# REEL IN BETTER

## Universal Joint Changes

# BRACKET

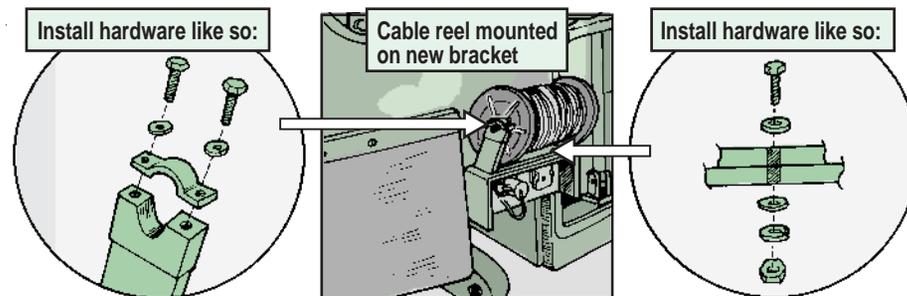
1. Mark four hole locations on top of the NATO slave receptacle guard like so:

Lay the new bracket, NSN 2590-00-933-9011, on top of the guard to make sure the holes will line up.

2. Drill four  $\frac{7}{16}$ -in diameter holes using drill bit, NSN 5133-00-227-9670, from the No. 1 Common shop set.
3. Install the new bracket using four screws, NSN 5305-00-068-0511; eight flat washers, NSN 5310-00-080-6004; four lock washers, NSN 5310-00-637-9541; and four nuts, NSN 5310-00-732-0558.
